PRELIMINARY ASSESSMENT REPORT: Addendum

For the Revised Location of Markham MTS No. 4

CAA ID No. 2002-054

Date: 15th July 2002

*Provision of Additional Transmission Support to
a new Switching Facility at Parkway Junction
(500kV Option)*

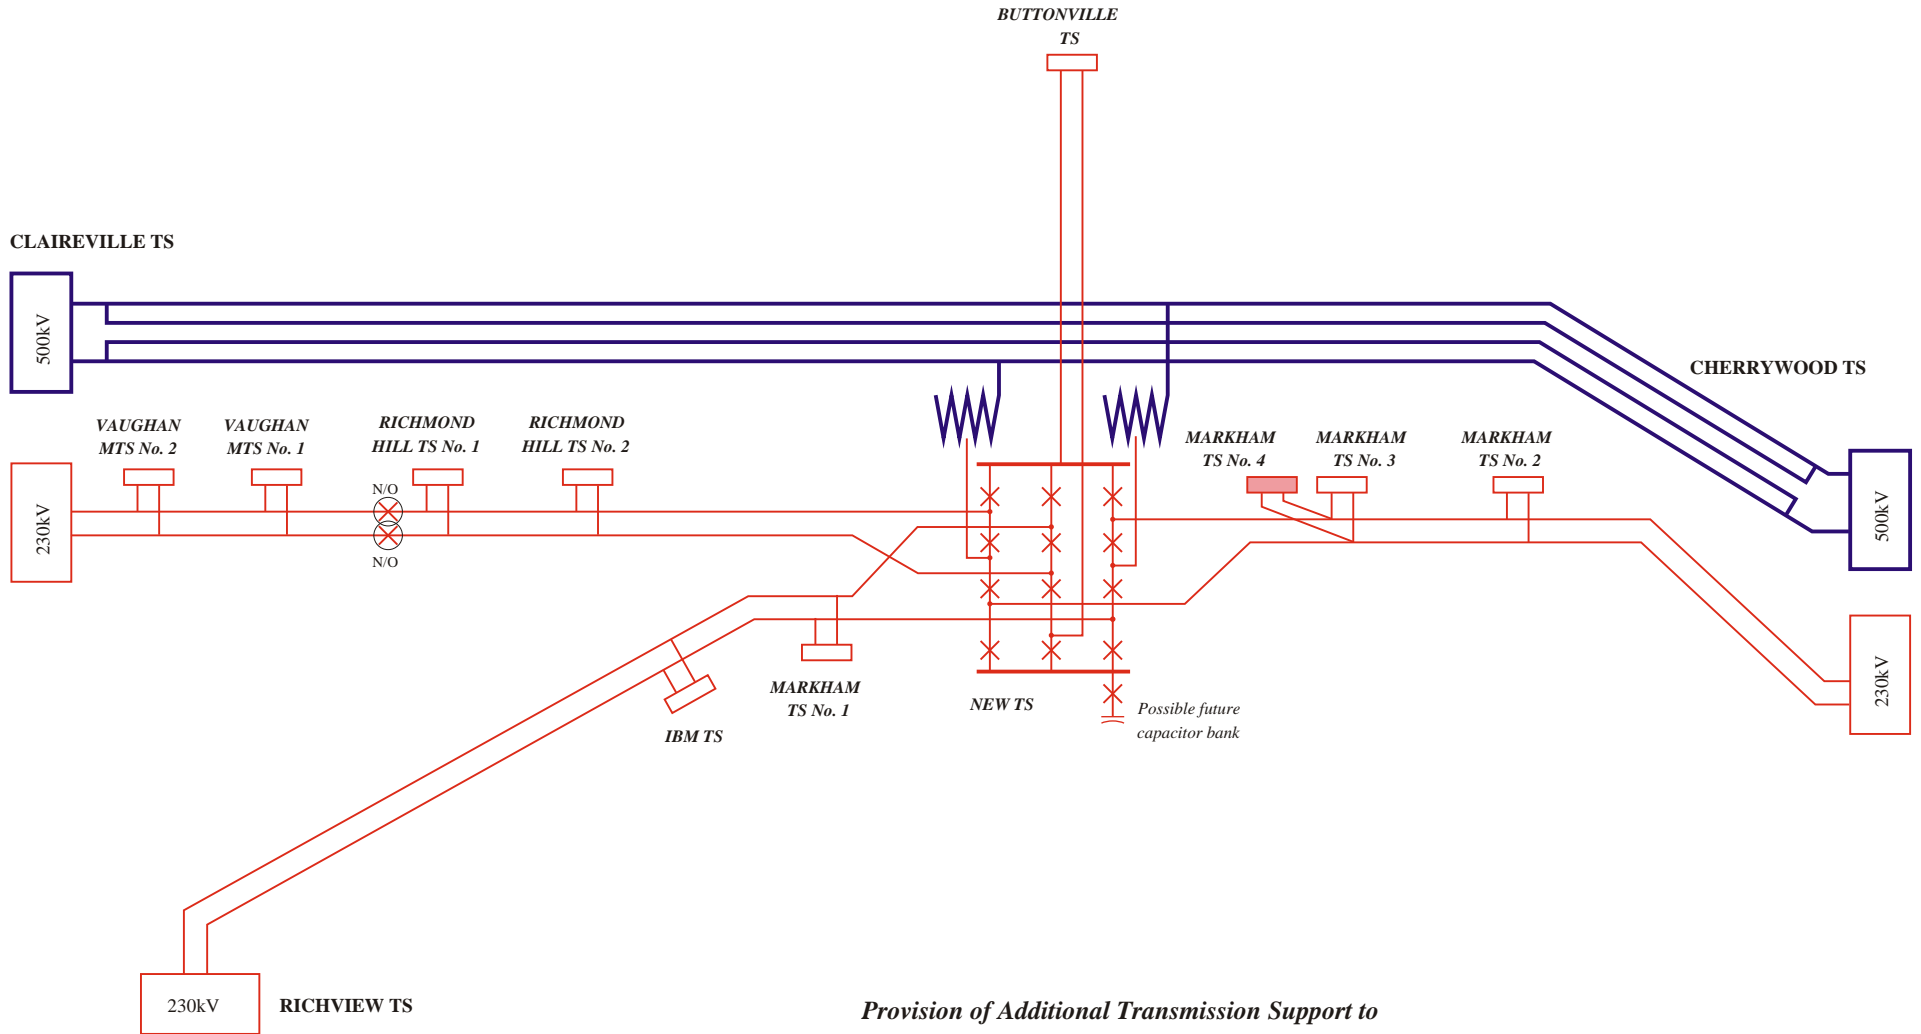
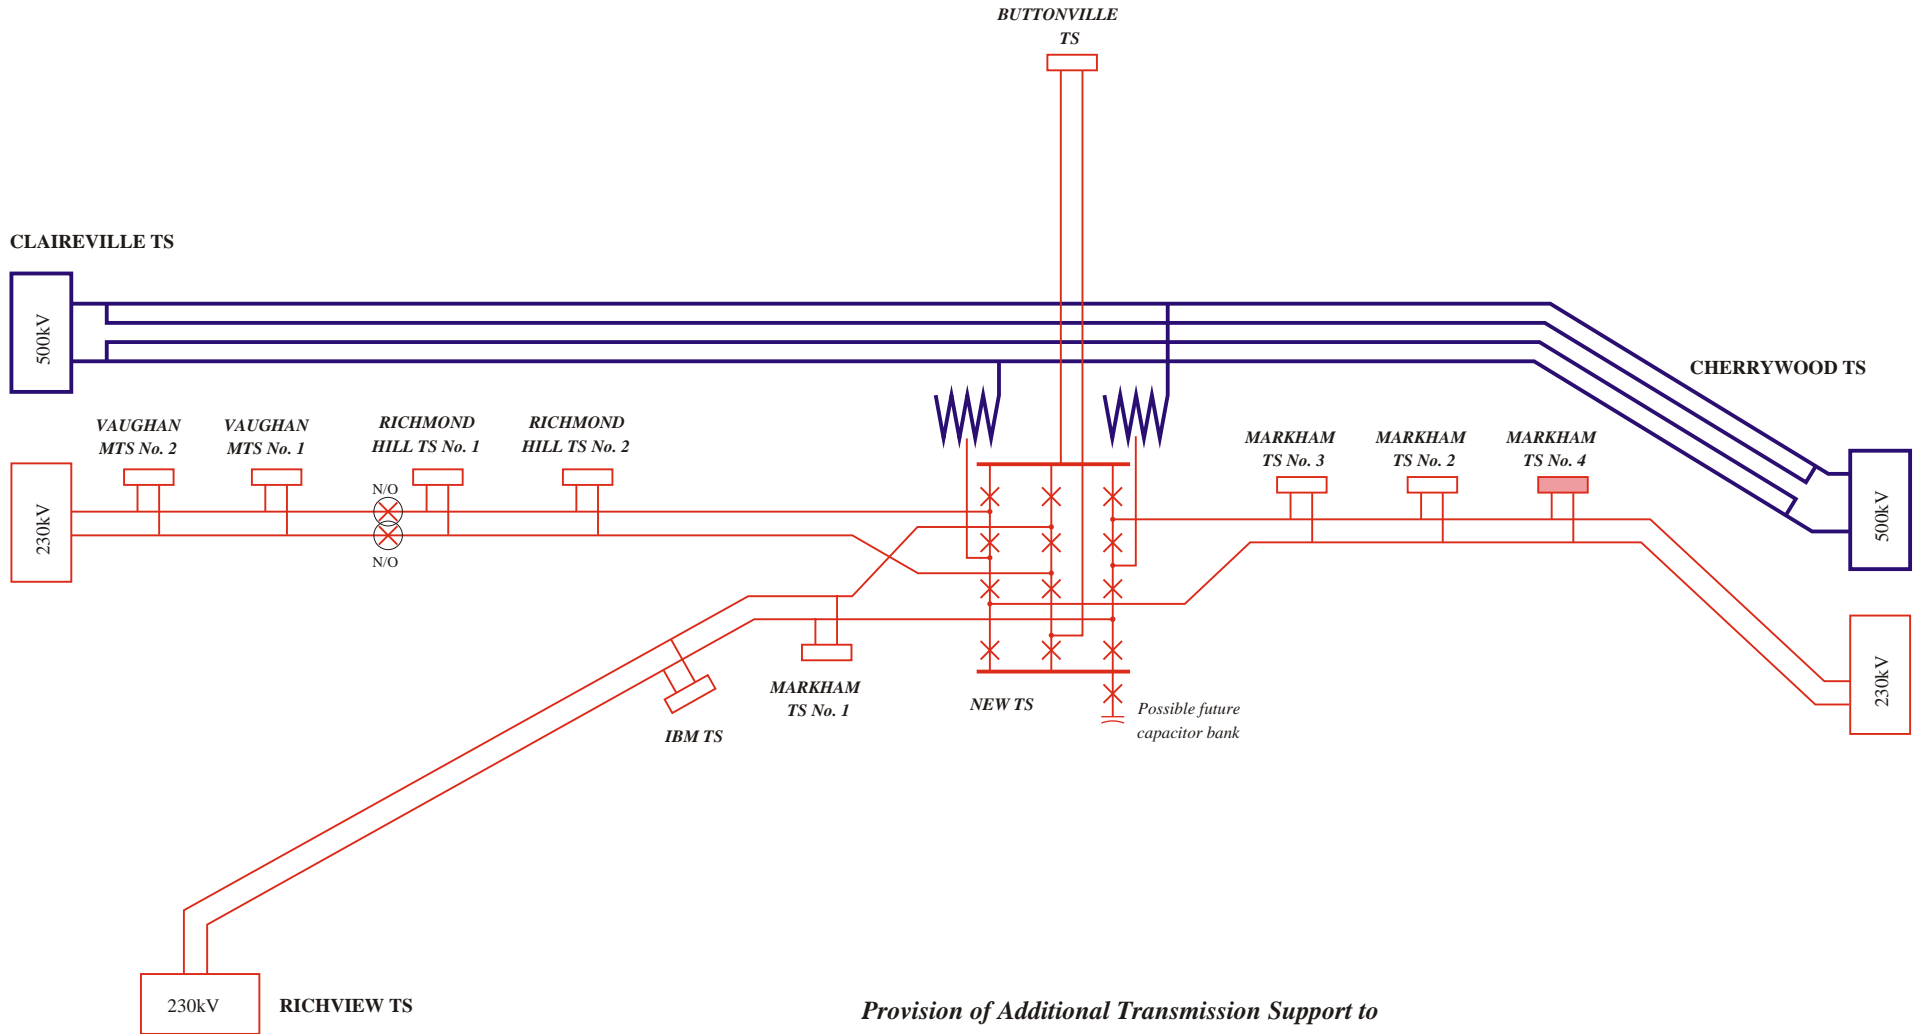
Diagram 6 shows an arrangement with two 500/230kV auto-transformers, connecting the new Parkway Junction switching station directly to the 500kV system.

- The two new 500/230kV auto-transformers would reduce the loading on the existing 500/230kV auto-transformers at Cherrywood TS.

DIAGRAM 1

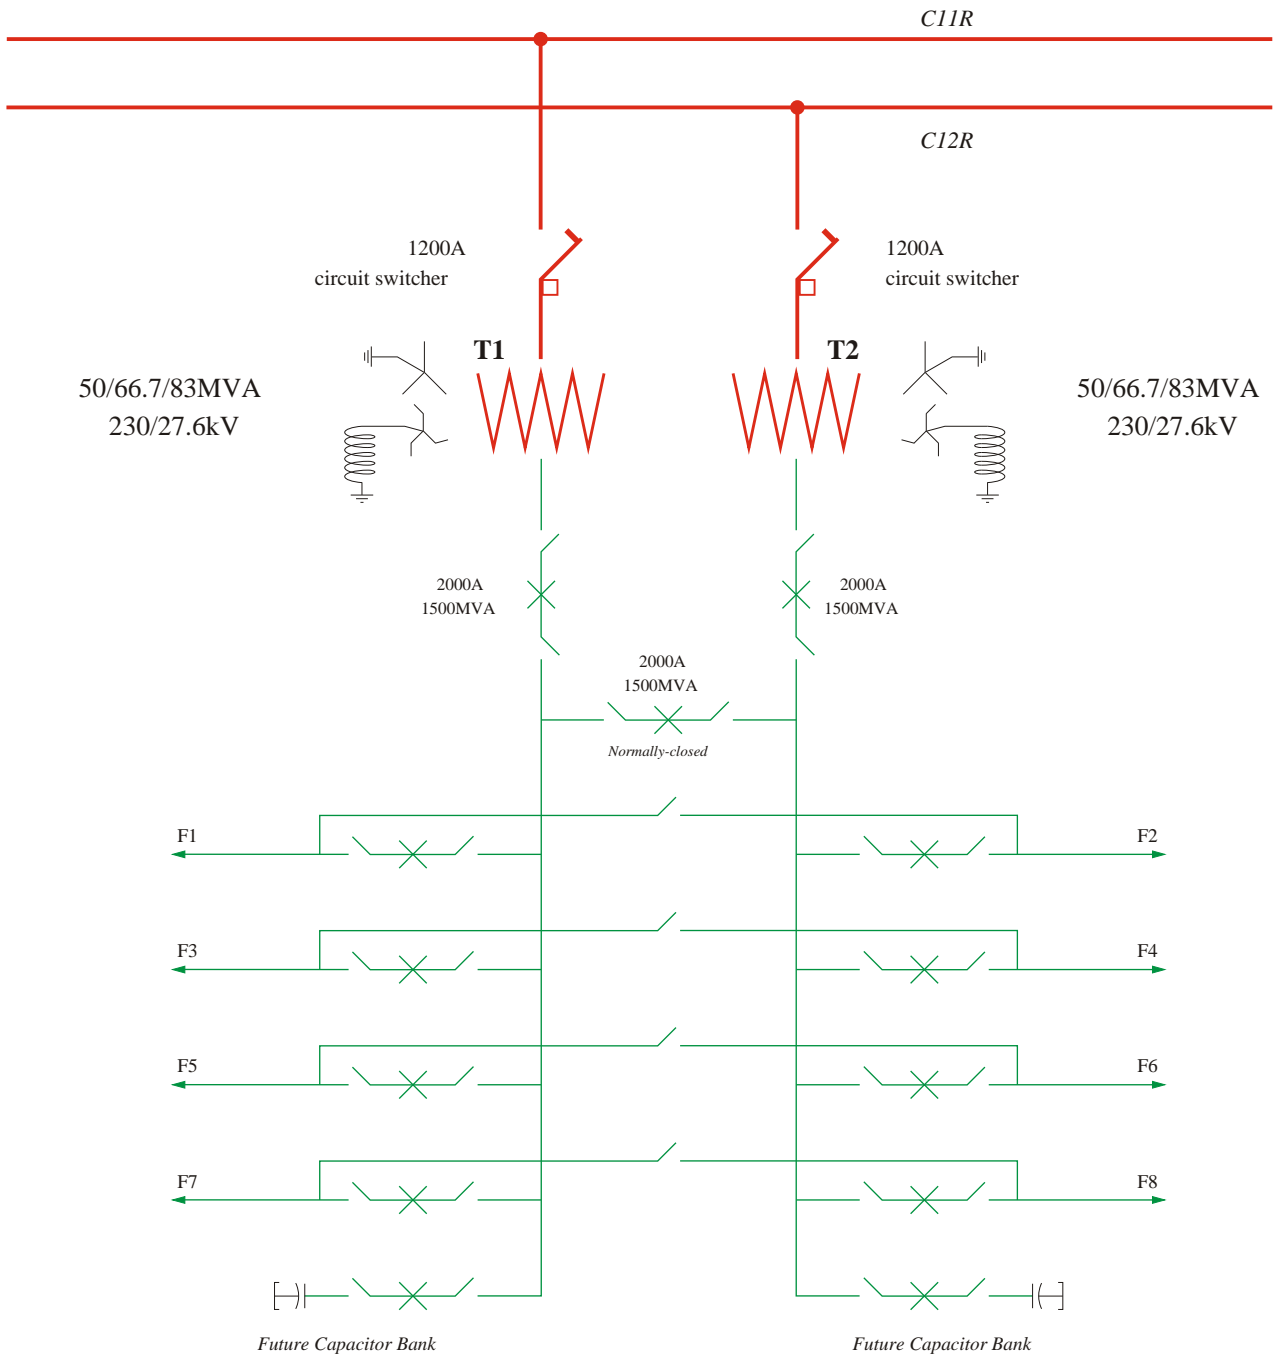
Diagram 1 shows the proposed configuration of the new MTS and its connection on to circuits C11R & C12R.

Since the fault levels at the new Markham MTS No. 4 are expected to exceed the fault interrupting capability of the new 230kV circuit switchers, it will therefore not be possible to use them to isolate transformer faults. Isolation of transformer faults would therefore need to be achieved by sending remote trip signals to the terminal stations to trip the main 230kV circuit. However, apart from routine switching of the transformers, either into service or out-of-service, the circuit switchers could be used as back-up for the clearance of LV faults in the event that the LV breakers should maloperate.

While it is acknowledged that the load on the new MTS is expected to be relatively light during the initial years of operation, Markham Hydro should consider installing at least one of the new capacitor banks at the outset, and to partially equip it with a reduced number of capacitor cans to provide a lower initial value. This would ensure compliance with the Market Rules while also allowing a more prompt response should the load develop at a faster rate.
